2023 SMP Package III (Hermine Blvd, Bartmer Ave)
Solicitation No. CO-00574
Job No. 21-5056 (Water) & 21-5554 (Sewer)

ADDENDUM 1
September 14, 2022

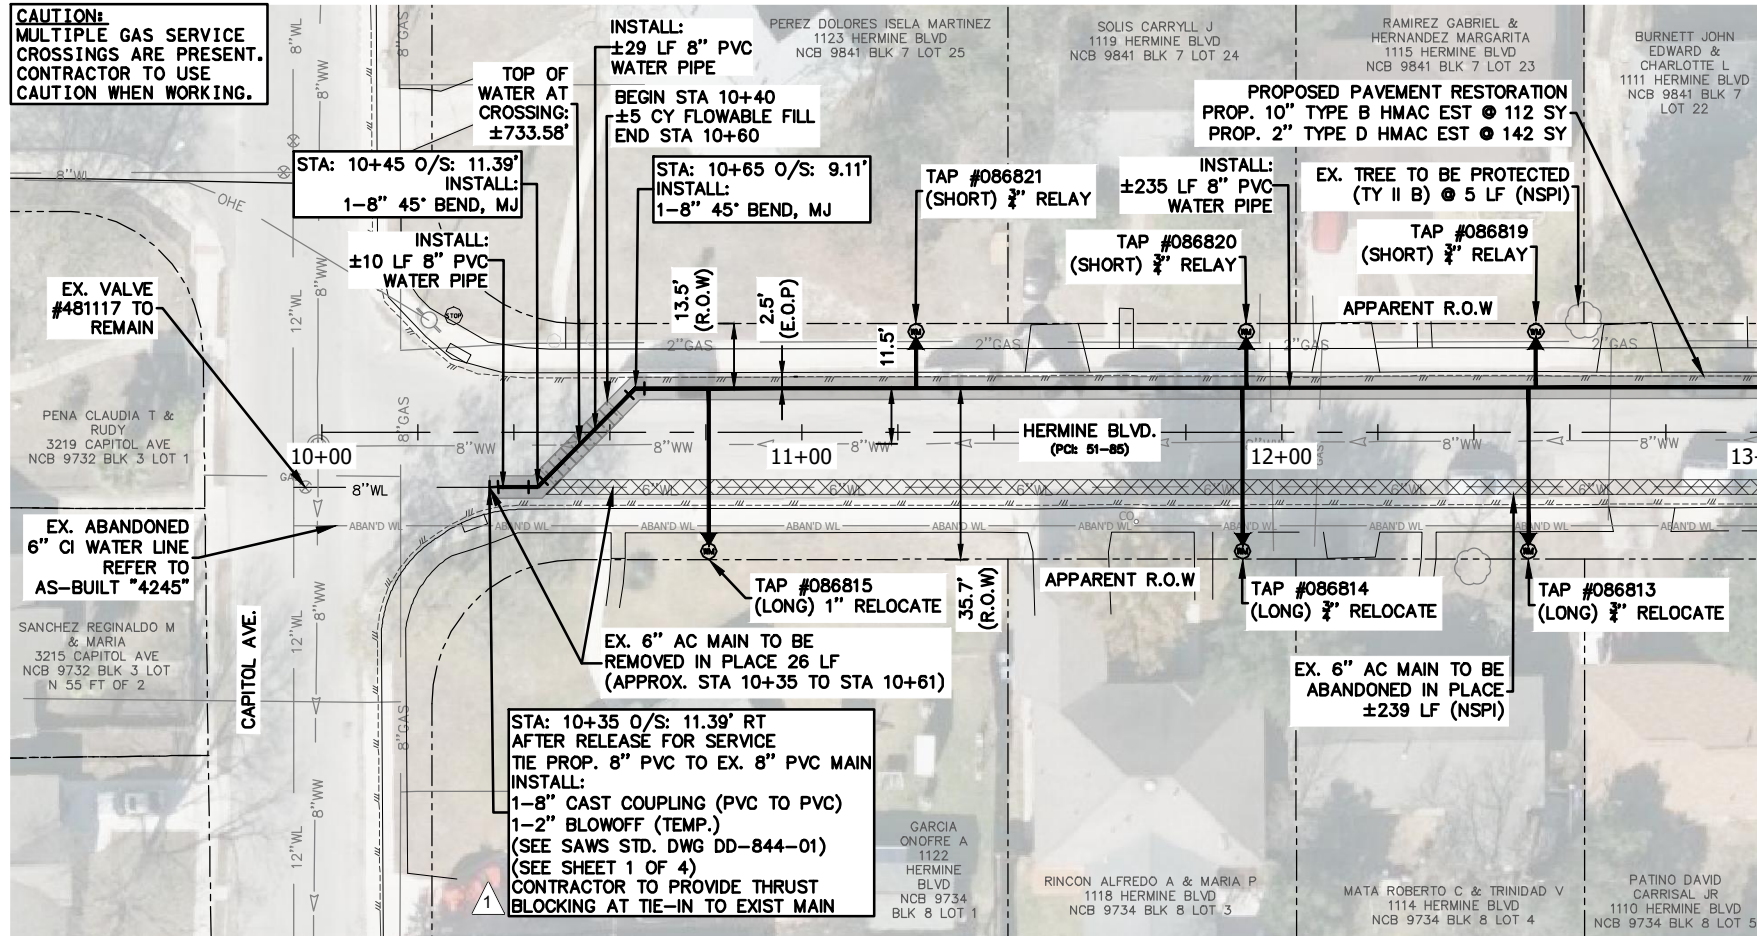
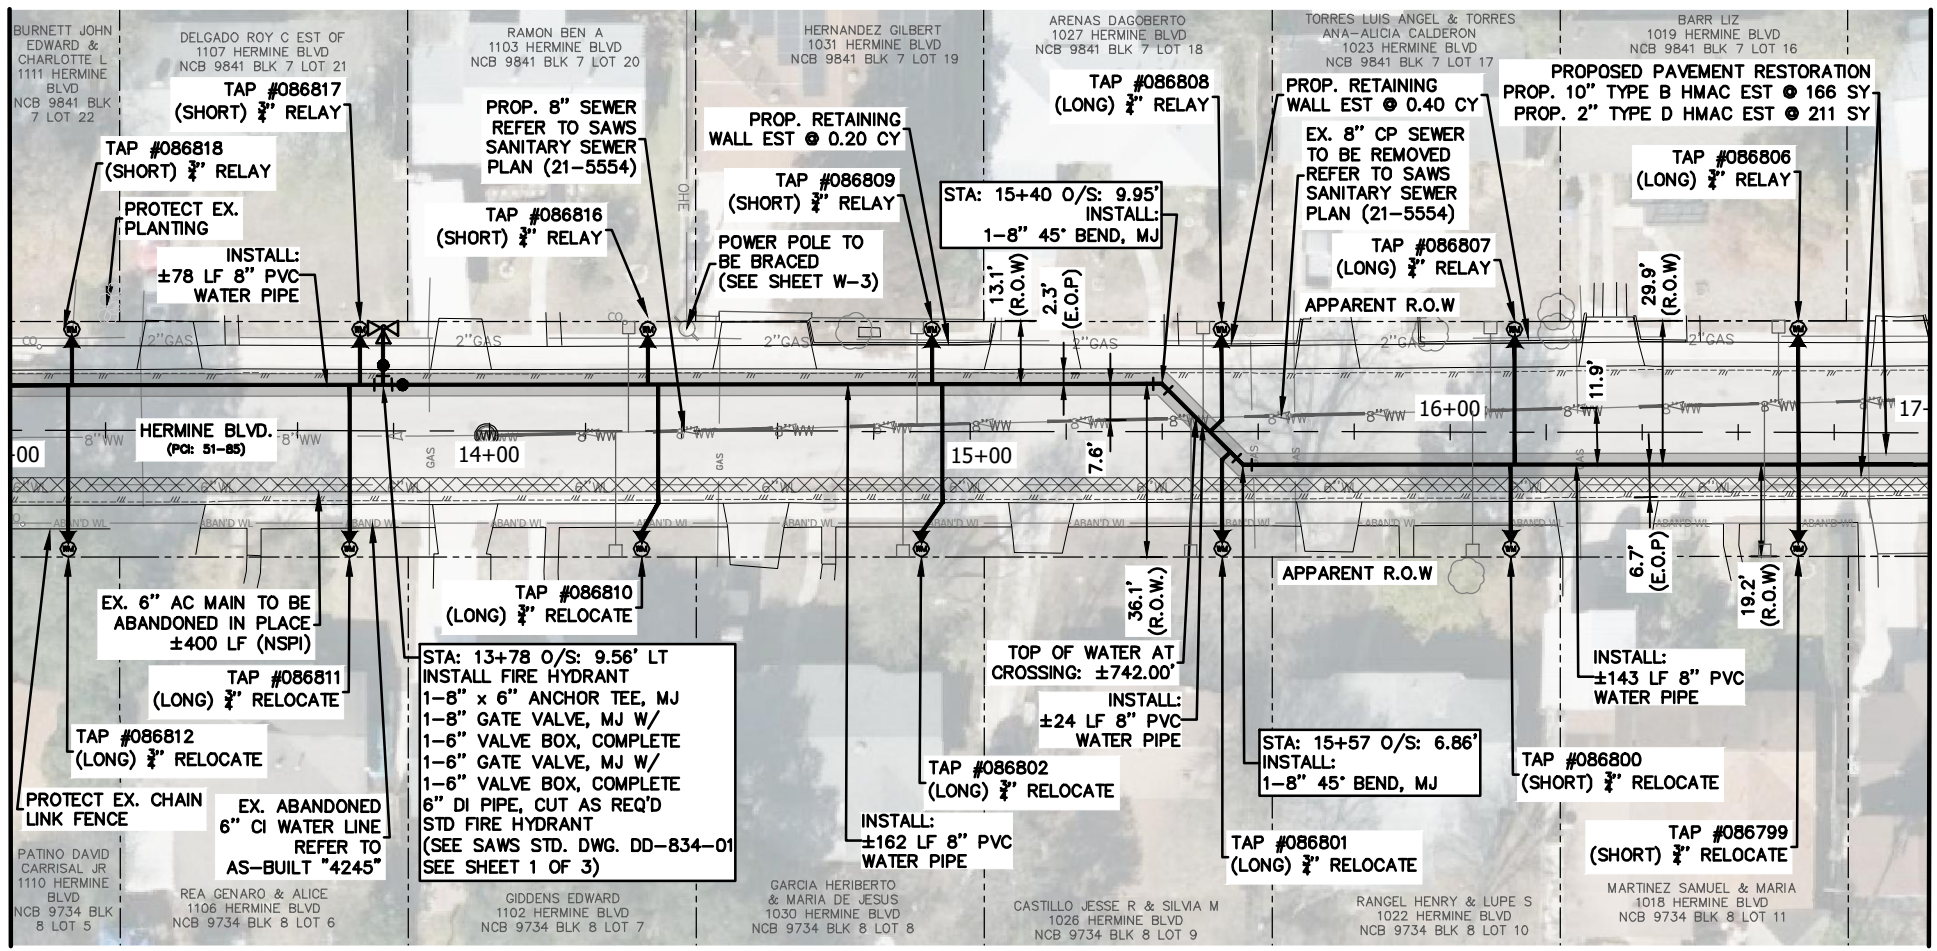
6. **Sheet W-17 Hermine Blvd. Water Main Replacement Begin Project To Sta 17+00 – Note 8 "CONTRACTOR TO FULLY RESTRAINED ALL PIPE" has been replaced with "SEE SHEET W-23 FOR RESTRAINED LENGTH TABLE".**

7. **Sheet W-17 Hermine Blvd. Water Main Replacement Begin Project To Sta 17+00 – tie-in callout at Capitol Ave. to include the following “CONTRACTOR TO PROVIDE THRUST BLOCKING AT TIE-IN TO EXIST MAIN”**

- SEE SHEET W-23 FOR RESTRAINED LENGTH TABLE. REFER TO SAWS SPECIFICATION 839 REGARDING RESTRAINED LENGTH.
- SAWS SHALL MACHINE CHLORINATE NEW WATER MAINS UNLESS OTHERWISE NOTED ON PLANS.

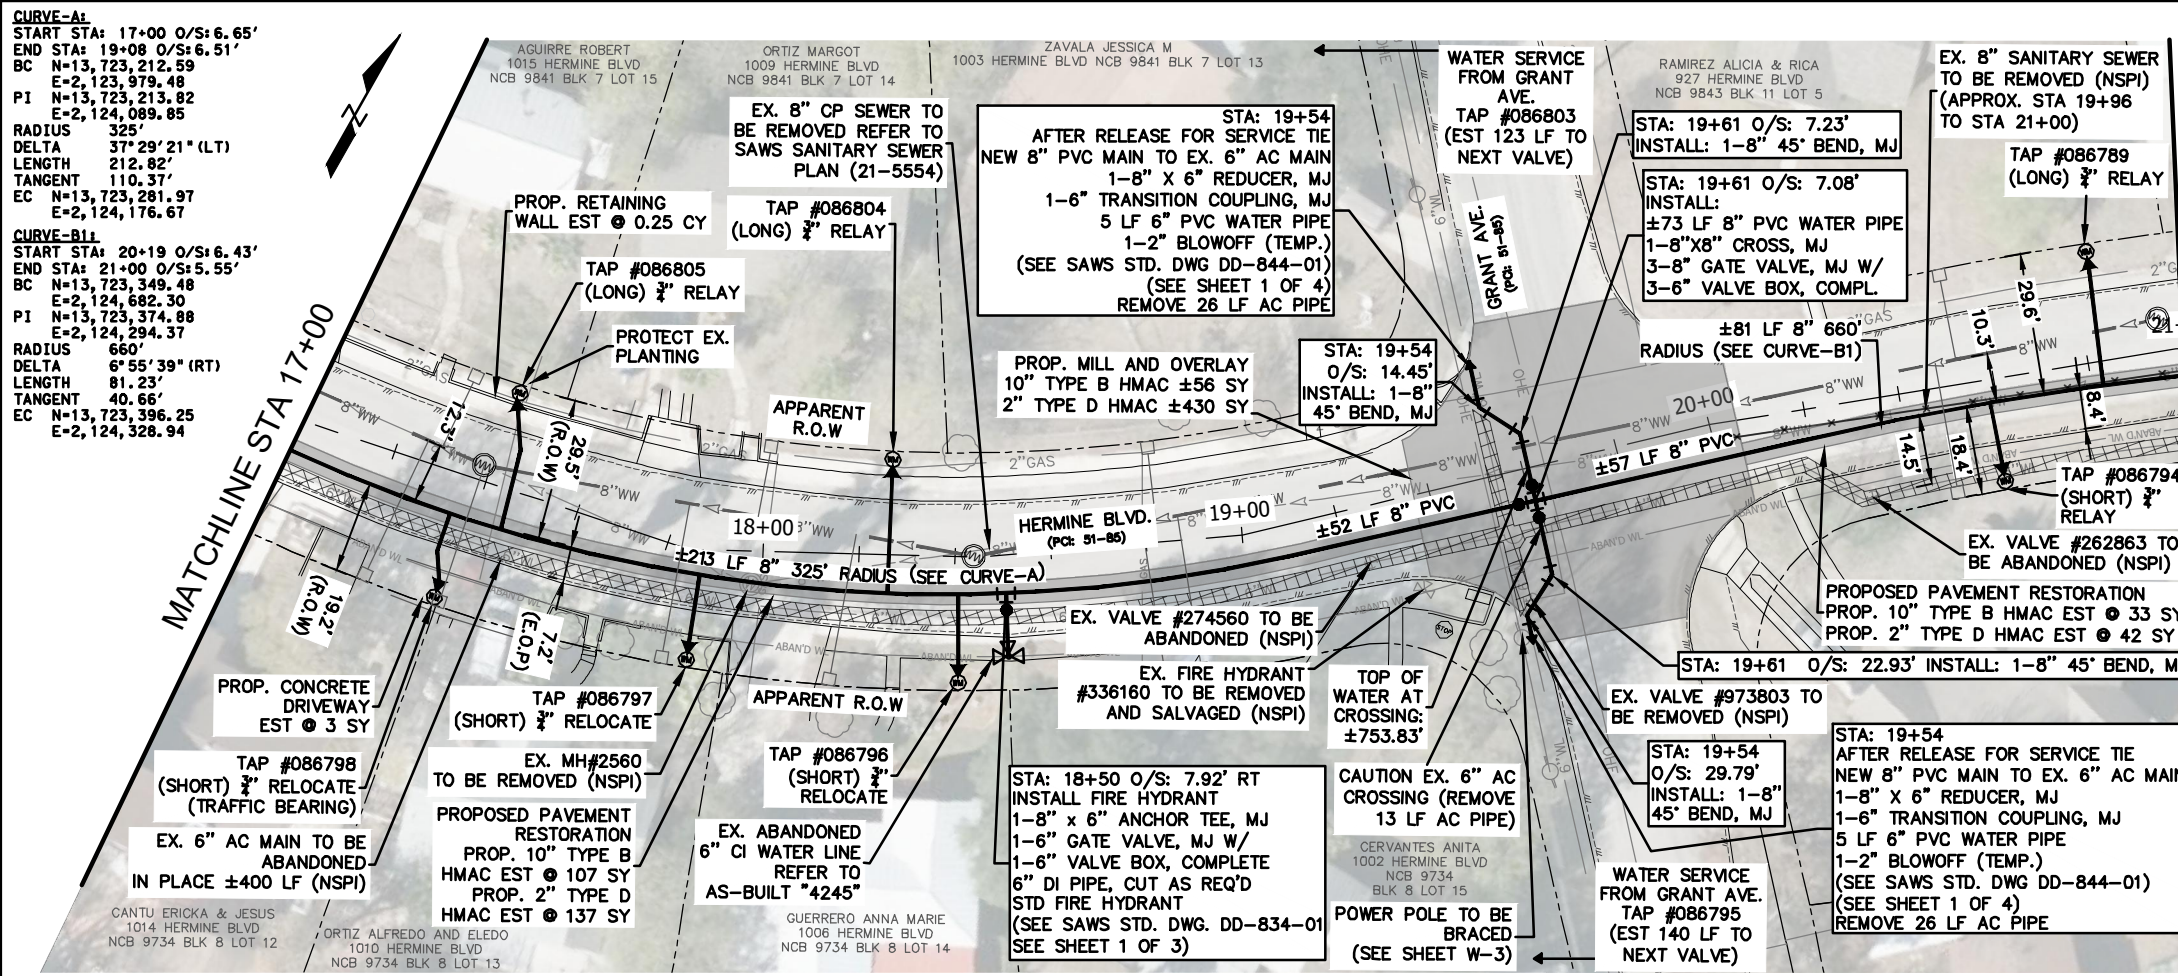
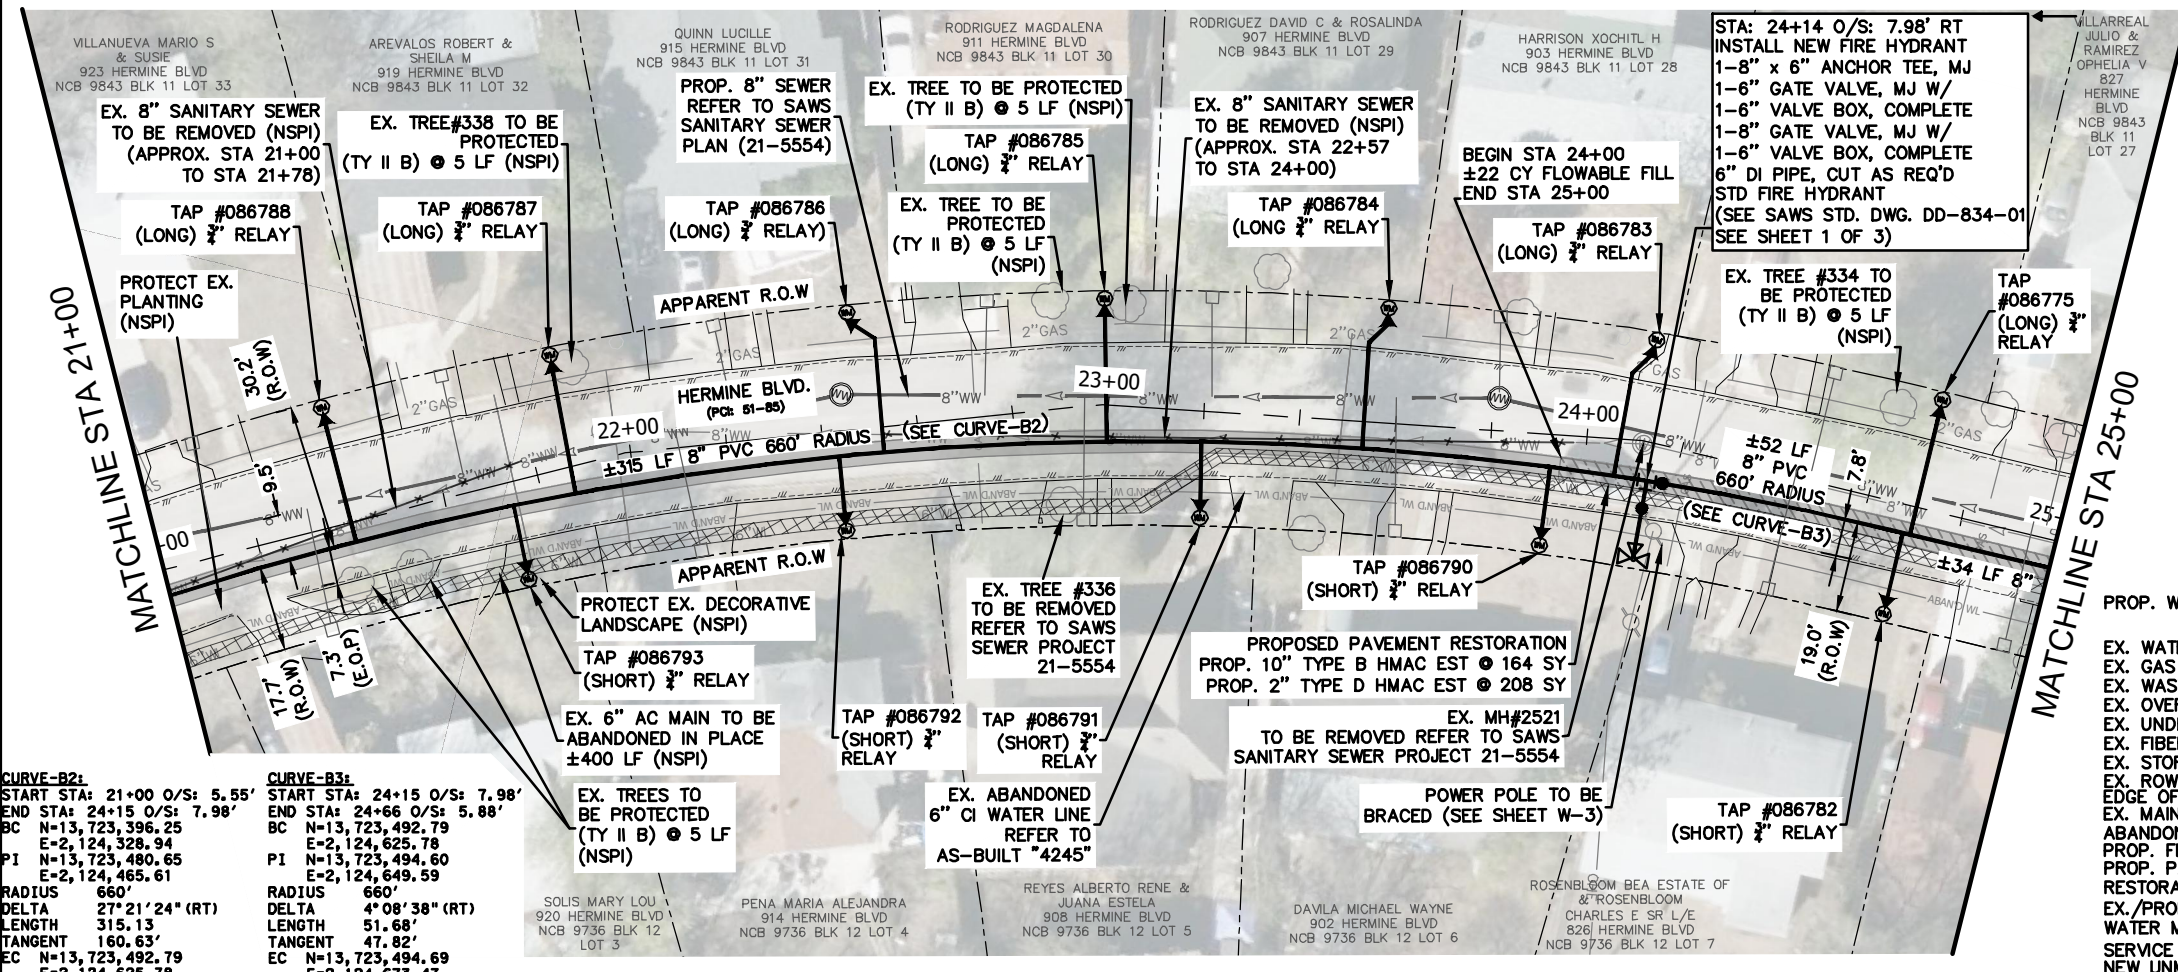
8. **Sheet W-18 Hermine Blvd. Water Main Replacement Sta 17+00 To Sta 25+00 – Note 8 "CONTRACTOR TO FULLY RESTRAINED ALL PIPE" has been replaced with "SEE SHEET W-23 FOR RESTRAINED LENGTH TABLE".**
9. **Sheet W-19 Hermine Blvd. Water Main Replacement Sta 25+00 To End Project – Note 7 "CONTRACTOR TO FULLY RESTRAINED ALL PIPE" has been replaced with "SEE SHEET W-23 FOR RESTRAINED LENGTH TABLE".**
10. **Sheet W-19 Hermine Blvd. Water Main Replacement Sta 25+00 To End Project – tie-in callout at Blanco Rd. to include the following “CONTRACTOR TO PROVIDE THRUST BLOCKING AT TIE-IN TO EXIST MAIN”**
11. **Sheet W-23 Miscellaneous Details – Trench – Restrained Length Table included for Bartmer Ave. and Hermine Blvd.**

- SEE SHEET W-23 FOR RESTRAINED LENGTH TABLE. REFER TO SAWS SPECIFICATION 839 REGARDING RESTRAINED LENGTH.
 - SAWS SHALL MACHINE CHLORINATE NEW WATER MAINS UNLESS OTHERWISE NOTED ON PLANS.
